DEVELOPMENT REVIEW BOARD

Planning - Case Comments

***Project Number**: PR-2018-001405*

***Project Name**: 201 Unser/7901 Central*

Proposed

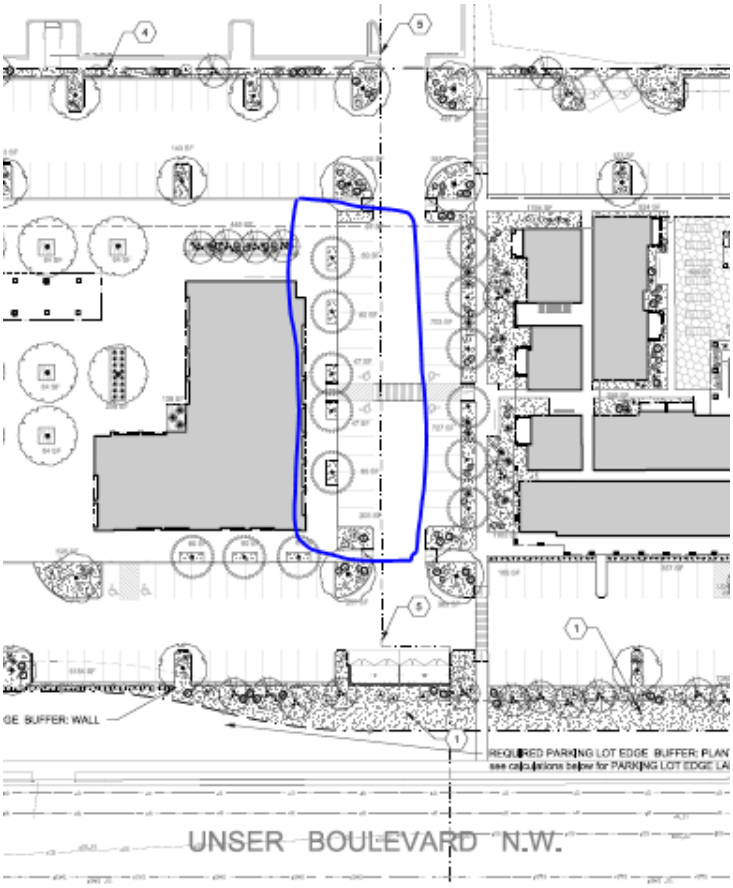
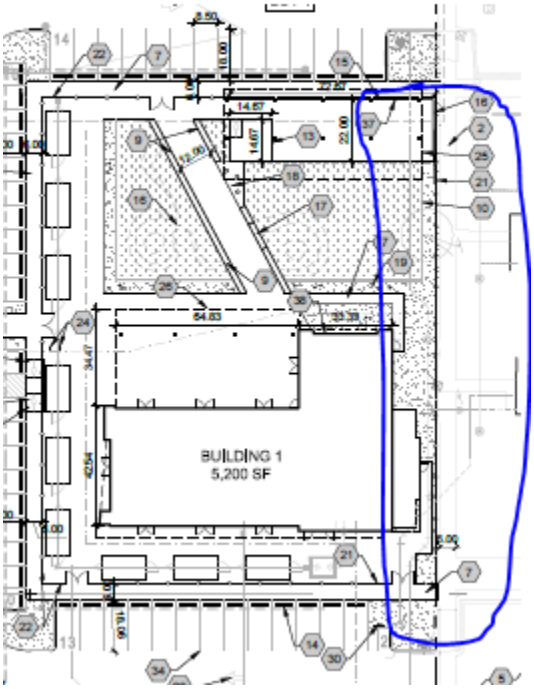
- There is a row of trees on the existing Site Plan that provides some landscape buffer between the commercial and the multi-family. Please show how the proposed landscaping provides equivalent or better landscaped buffering to the multi-family development.
